# Aman Knittings Ltd.

Nijim Nagor, Singair Road, Hemeyetpur, Saver, Dhaka  
(23.794351N, 90.269603E)  
30<sup>th</sup> April 2014

# Observations

# Floor Finishes Cracking Around Column Perimeter

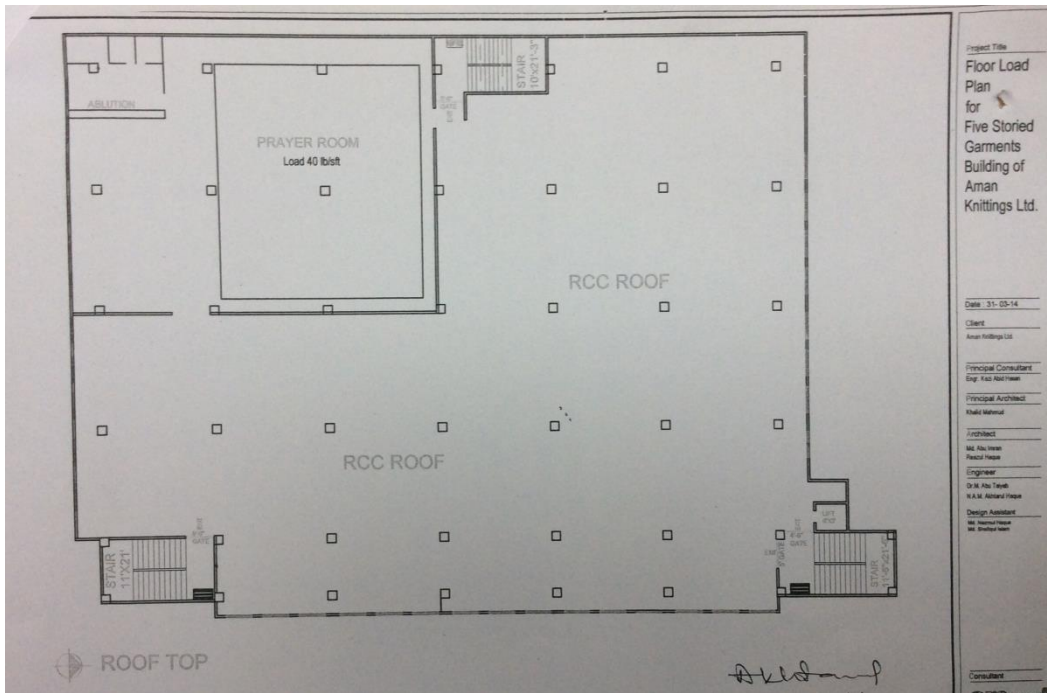
We observed cracking on the floor finishes all around the column at 4<sup>th</sup> to a lesser extent on 3<sup>rd</sup> floor, but did not observe any on 2<sup>nd</sup> & 1<sup>st</sup> floors.

Item No.	Observation	Recommended Action Plan	Recommended Timeline
1	Cracking on slab around the perimeter of the columns	Detail Engineering Assessment of as built structure to be commenced as per attached scope. Using verified concrete strength and existing reinforcement of slabs, determine punching shear capacity of slabs at all levels	<b>Immediate - Now</b>
2	Cracking on slab around the perimeter of the columns	Detail Engineering Assessment to be completed	<b>6-weeks</b>
3	Cracking on slab around the perimeter of the columns	If punching shear capacity not justified with present arrangement, define strengthening detail around columns	<b>6-weeks</b>
4	Cracking on slab around the perimeter of the columns	Produce and actively manage a loading plan for all floors within the building giving consideration to floor slab and column capacity.	<b>6-weeks</b>
5	Cracking on slab around the perimeter of the columns	Continue to implement load plan	<b>6-months</b>

**Columns appear to be stressed in excess of normal design limits**

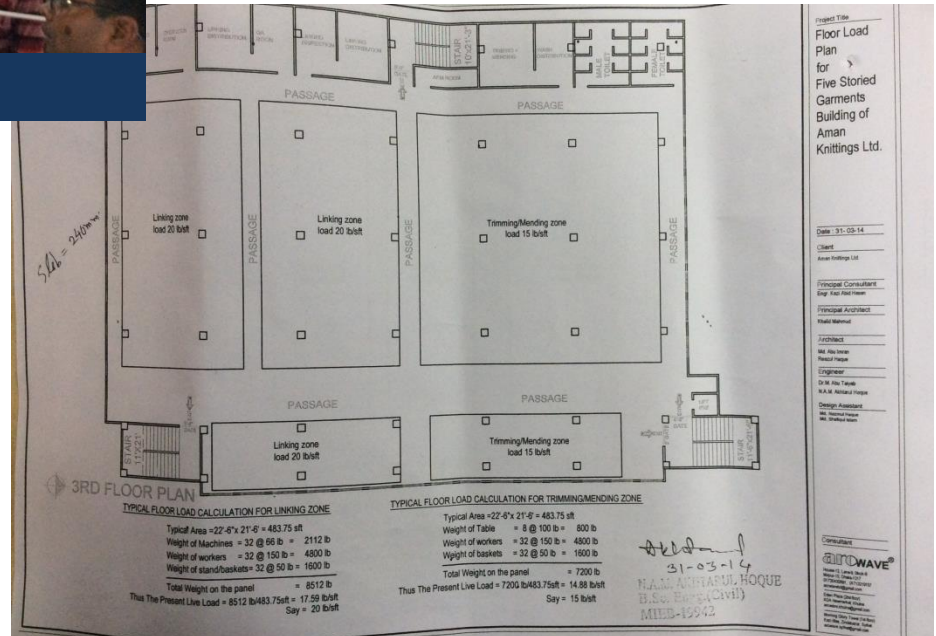
Cursory calculations indicate column working stress is in excess of normal design limits.

Building Engineer is to perform detailed calculations including a Detail Engineering Assessment (See attached scope) and concrete tests to prove column size and (if required):

- Reduce loads by vacating floors
- Reinforce columns

# Uncontrolled Loads

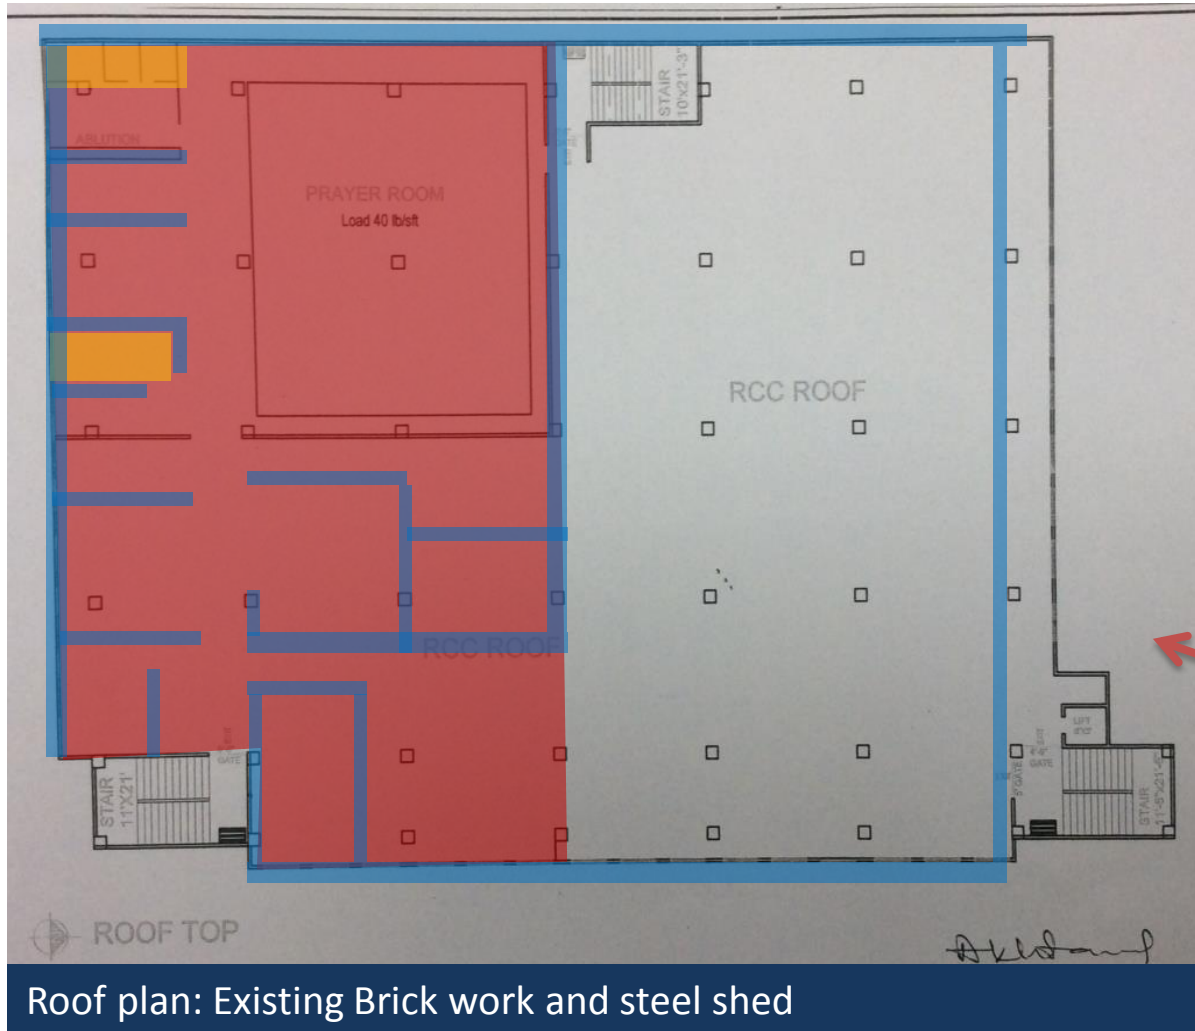
We observed a small area with uncontrolled loading at 3<sup>rd</sup> floor over one cantilever span. Management should maintain the loading limits.

Item No.	Observation	Recommended Action Plan	Recommended Timeline
16	Uncontrolled loads on the Eastern cantilever of the building	Reduce loading on the eastern side of the building where necessary. Produce and actively manage a loading plan for all floors within the building giving consideration to floor capacity and column capacity.	6-weeks
17	Uncontrolled loads on the Eastern cantilever of the building	Continue to implement load plan	6-months
18	Confirm stability of the non-engineered roofs over all sheds	Building Engineer to carry out design check to confirm stability of the steel roofs on all sheds.	6-months
19	Confirm stability of the non-engineered roofs over all sheds	If required, strengthen to support code loading.	6-months
20	Difference between permit drawings and as built construction	As part of the DEA required under Item 1, prepare as-constructed layouts of both buildings and resolve permitting inconsistencies.	6-weeks
